Product Change Notice (PCN)

PCN Number: **PCN-045-0770R-01**

Product(s) Affected: *PJ-013D*

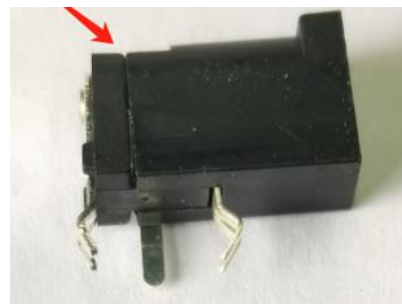
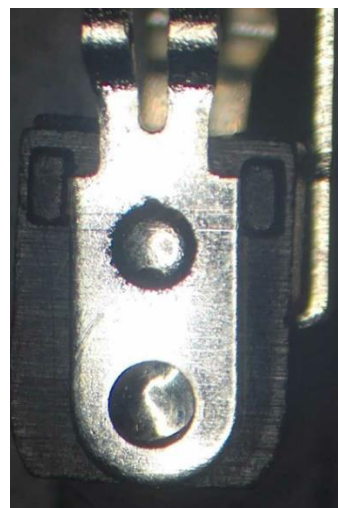
Description of Change: *Cosmetic Changes. * "Made in China" Removed. * Underside lettering removed. One additional rivet on the external metal contact pins. Please see image examples:*
